Disability Access Report

**Proposed Industrial
Development**

Meatworks Avenue
OXFORD FALLS NSW

For: Mr W Edwards
Ref: LP_19216

Figure 2 | Approach to Building

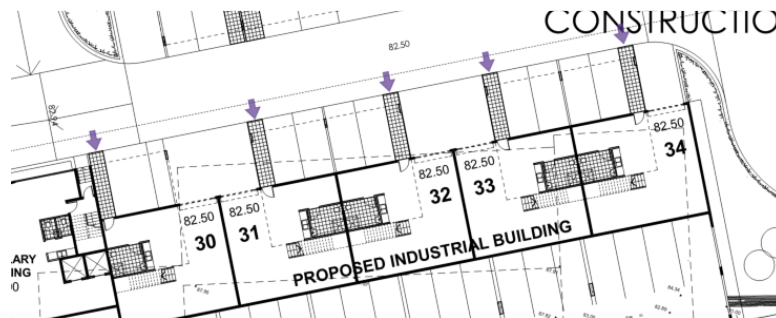
Direct access is provided to Units 30 – 34 inclusive from the Internal Roadway at the Ground Floor Level (RL 82.50).
